Job No: 2020-4359
Job Title: Euston One, William Road, Euston
File Ref: CA4359-N02-DR-Transport Response Note LBC (210518).docx
Date: 18th May 2021

Subject: 2020/5473/P: 17-37 William Road, LB Camden
Response to LB Camden's Highways and Transportation Comments and Queries

DAS Cycle Parking Extract

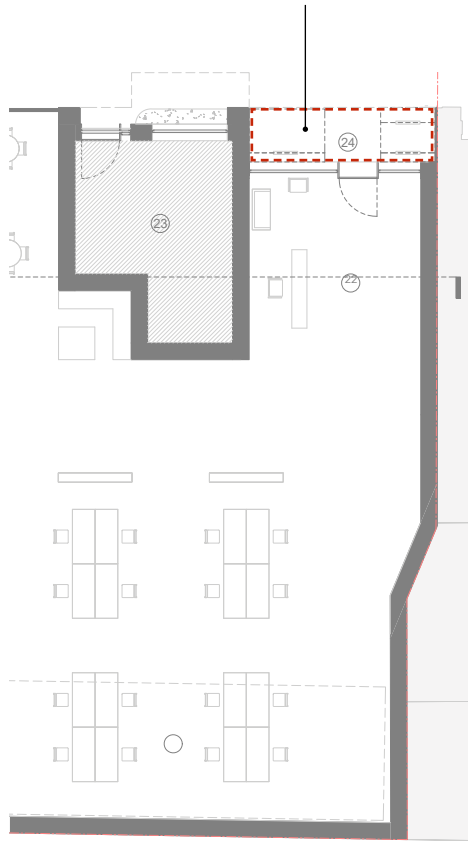
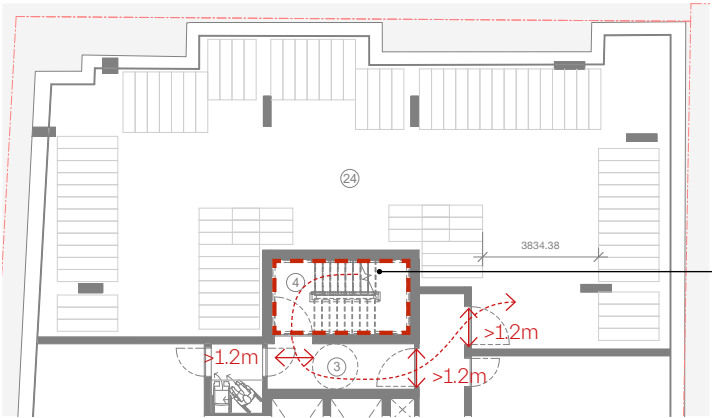
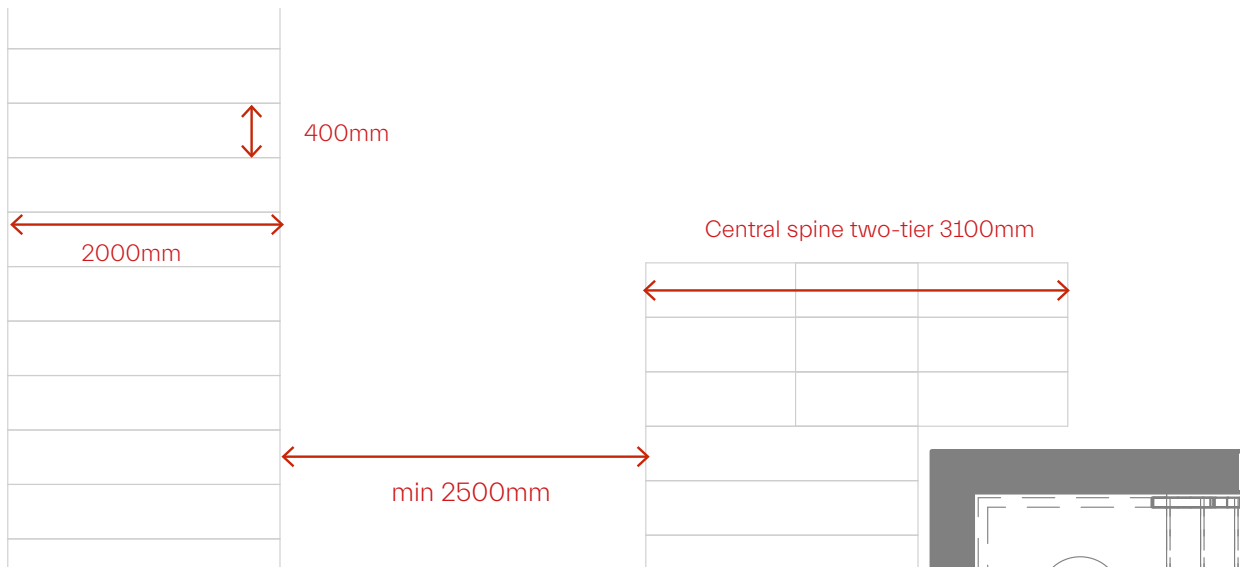
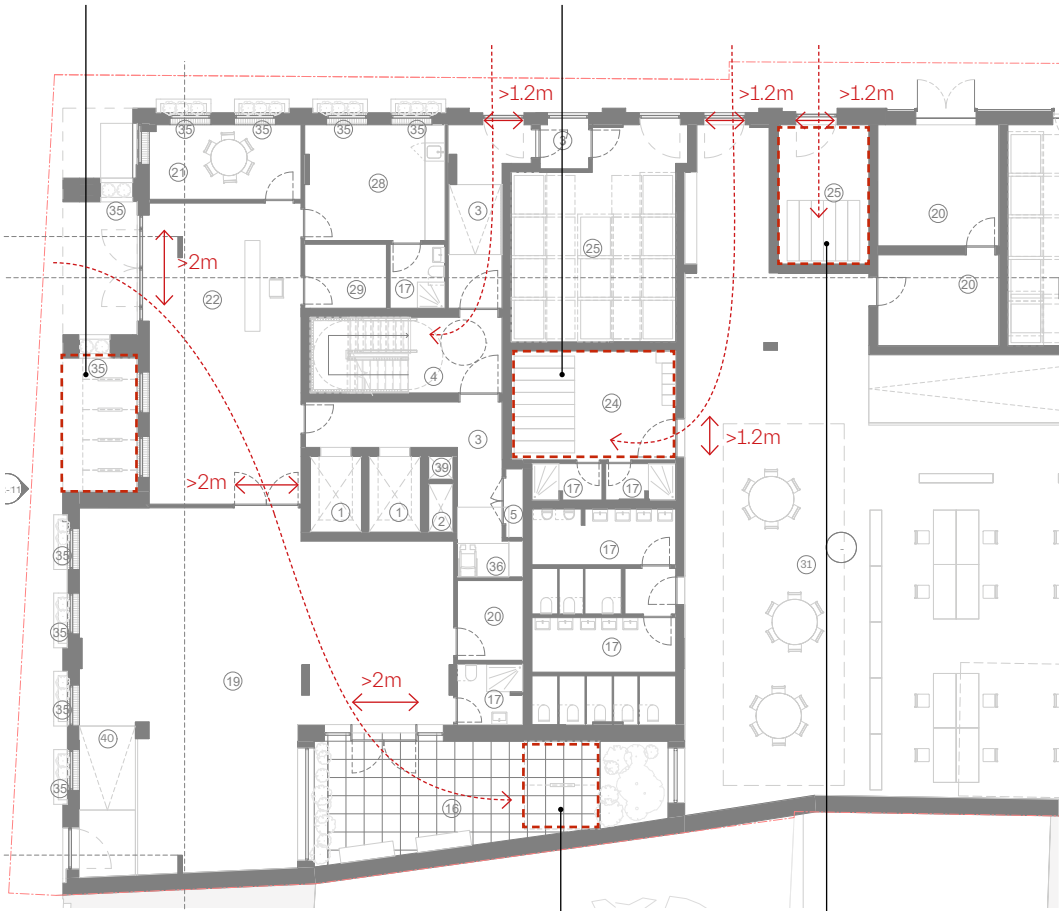
The types of cycle storage need to be identified on the drawings.

It is not clear from the drawings how these requirements are satisfied; the drawings just show rectangles. CPG Transport clause 8.11 requires: *Details of all cycle parking and associated facilities must be submitted at the pre-application stage and the full application stage in order for the Council to fully assess the transport implications of the proposals.* The types of cycle storage need to be identified on the drawings.

19. The types of cycle storage that are proposed are shown in the Design and Access Statement (DAS) that was submitted with the planning application. A copy of the relevant page is included in **Appendix B** for ease.
20. The information included in Appendix A demonstrates that the proposals include a wide range of cycle parking facilities that accord with the details included in the TA.

drawing title / location
BASEMENT STAIR WITH CYCLE RAMP

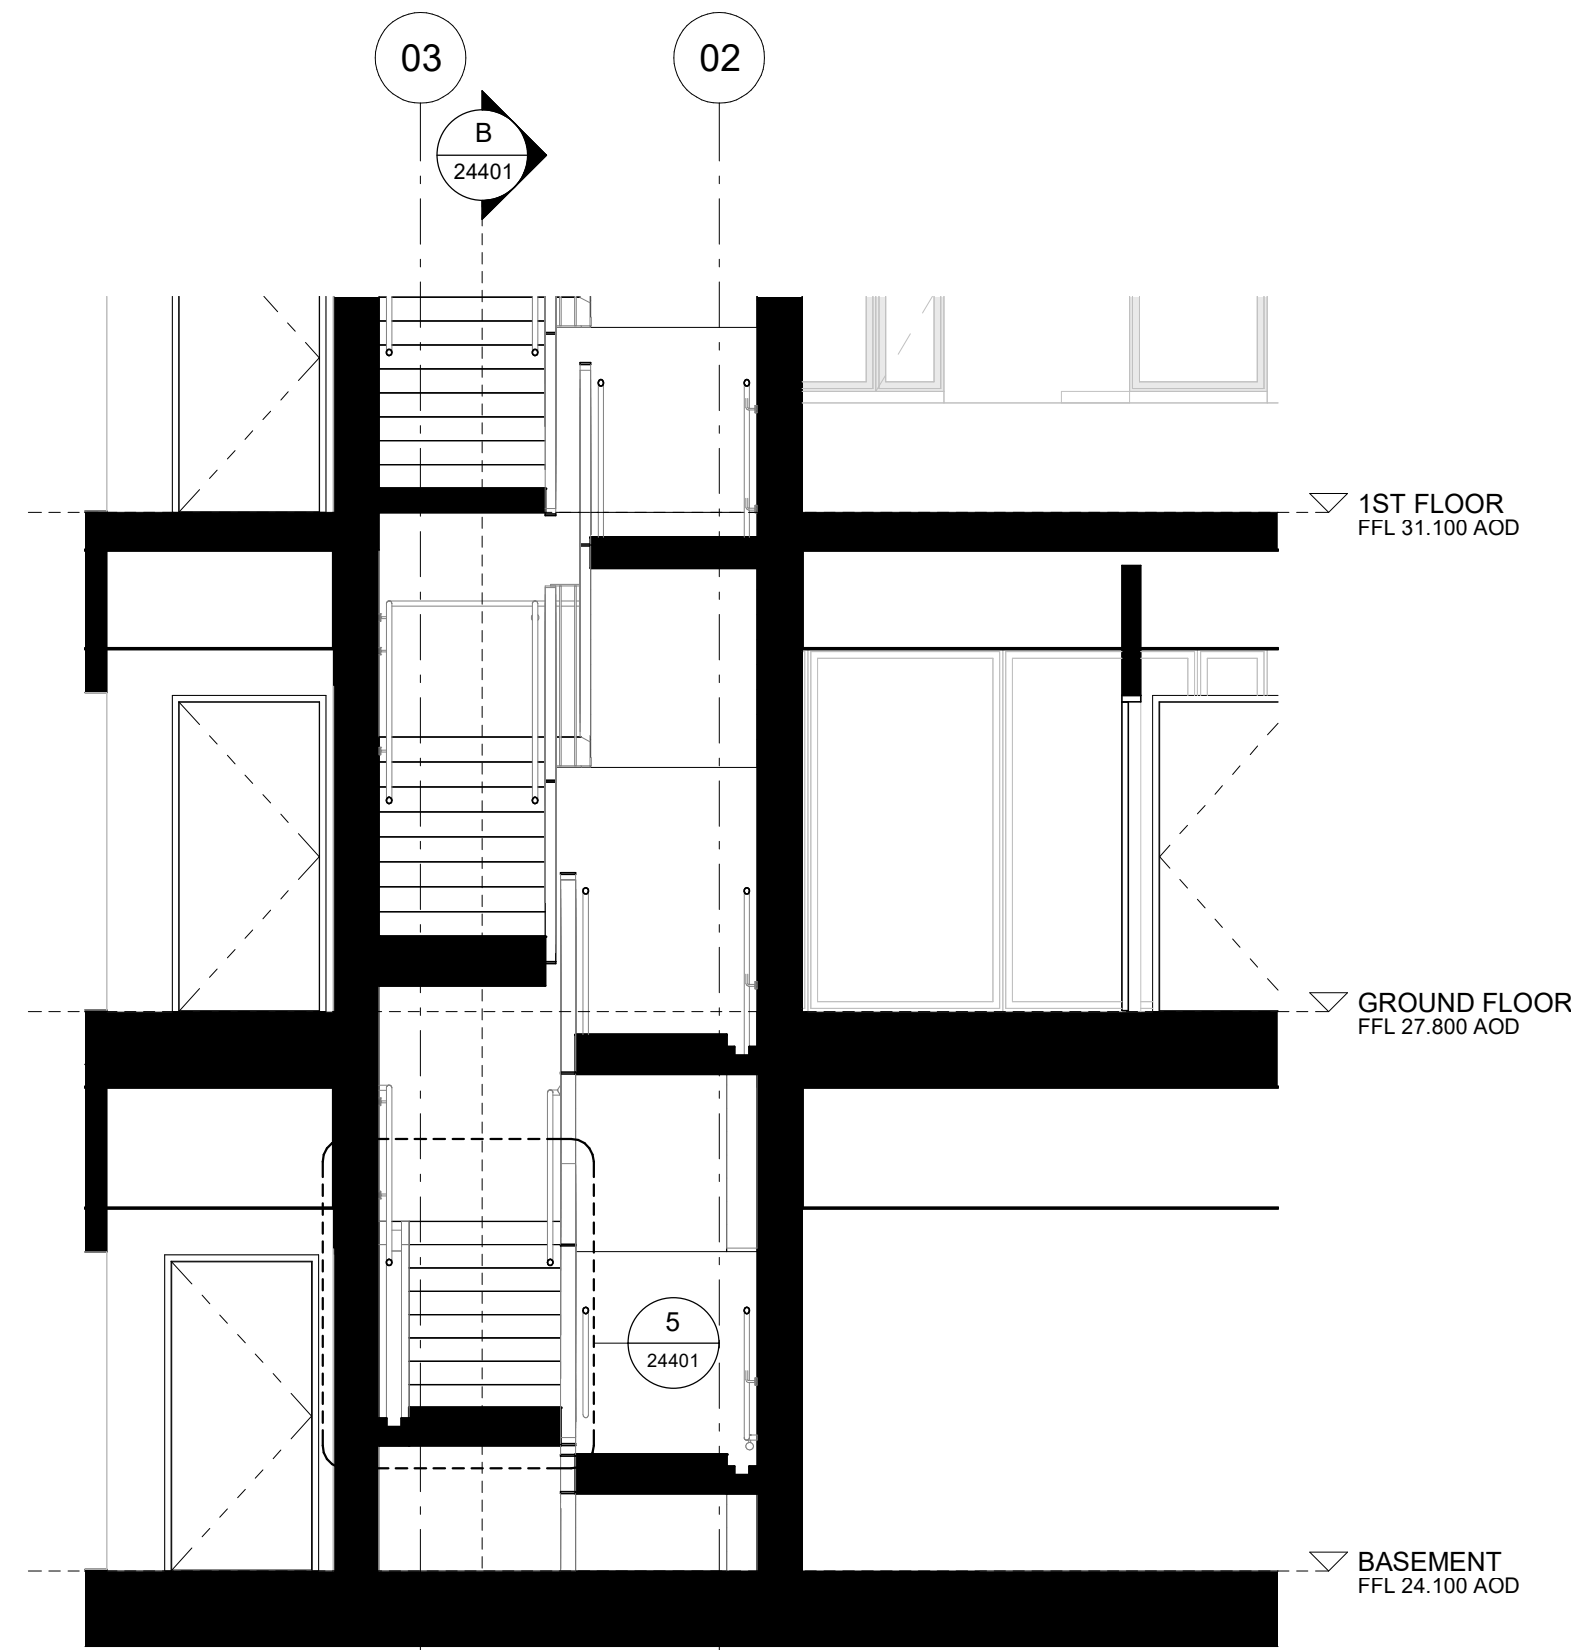
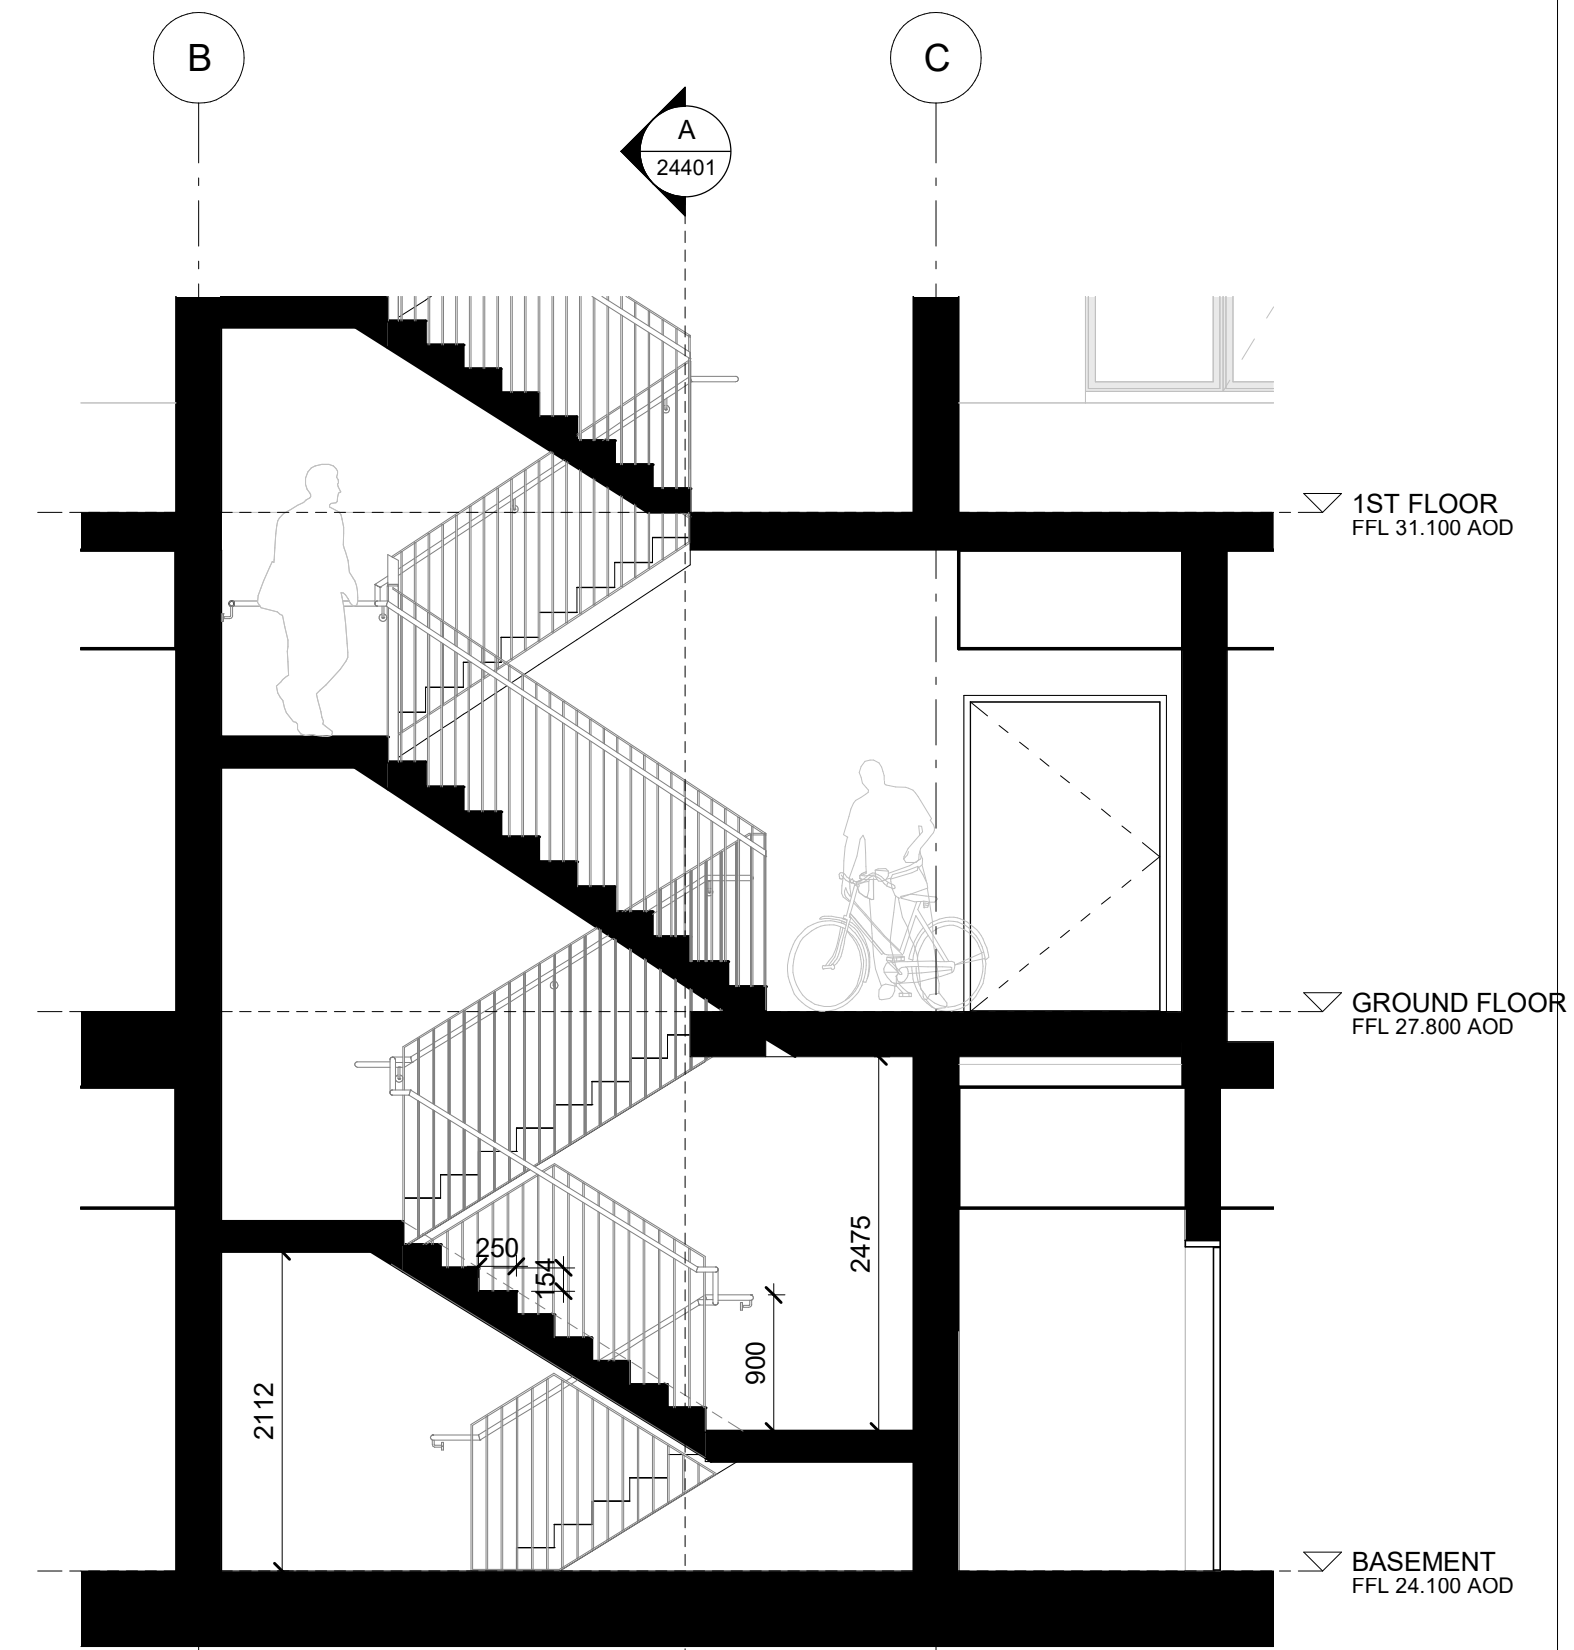
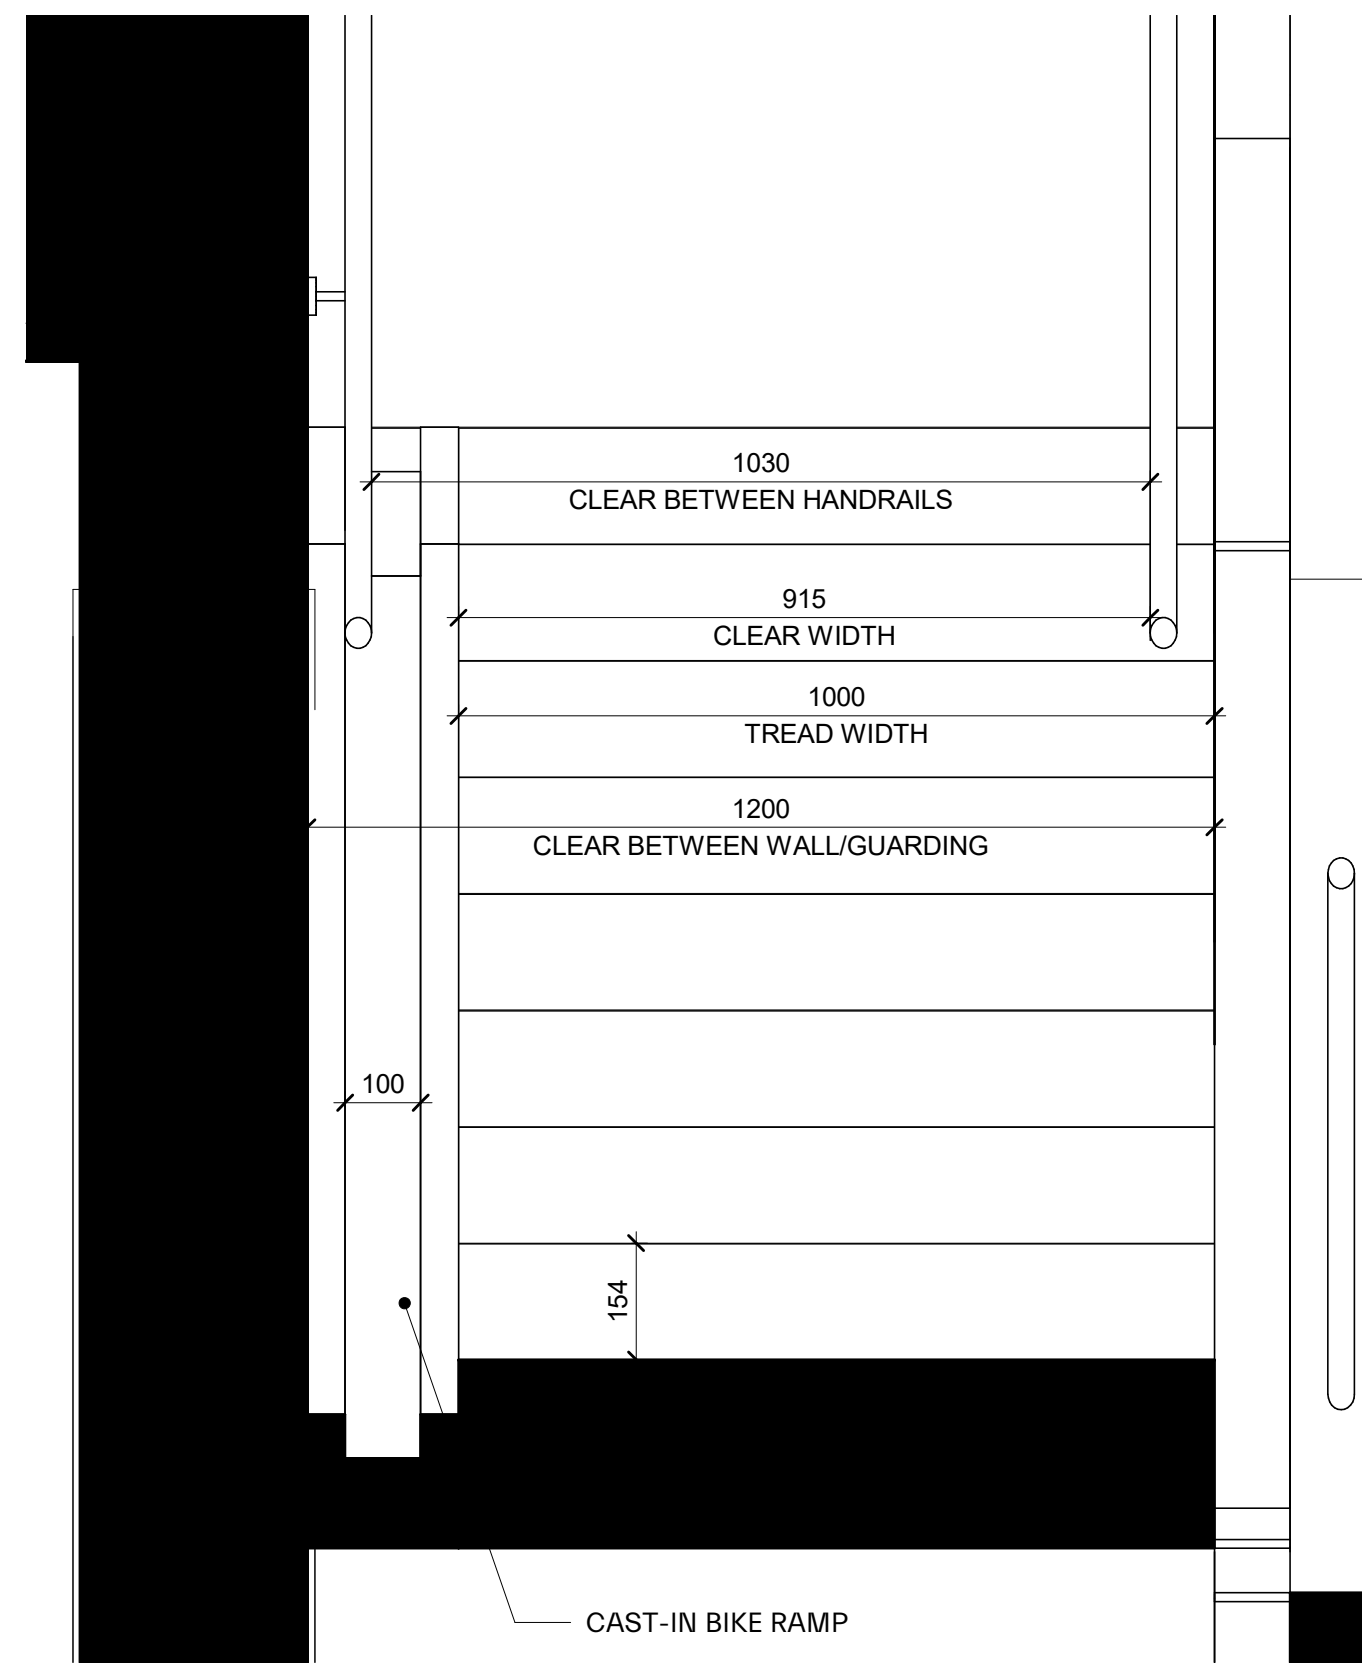
The Stair Ramp needs to be shown on the drawings.

The TA refers to: *Two-Tier Racks at Basement Level accessed via Lift or Stair Ramp.* The Stair Ramp needs to be shown on the drawings. It should be noted that the dimensions of the proposed lifts fall short of the requirements of CPG Transport clause 8.16: *The route to cycle parking from street level must be step free. If level access is unachievable, the cycle parking must be accessible via a ramp or a lift that is adequate in size to accommodate a cycle and its user. Lifts should measure a minimum of 2m x 2m, although where many users are likely to arrive at a similar time, for example at a large*

21. **Appendix C** includes a drawing showing the Stair Ramp.
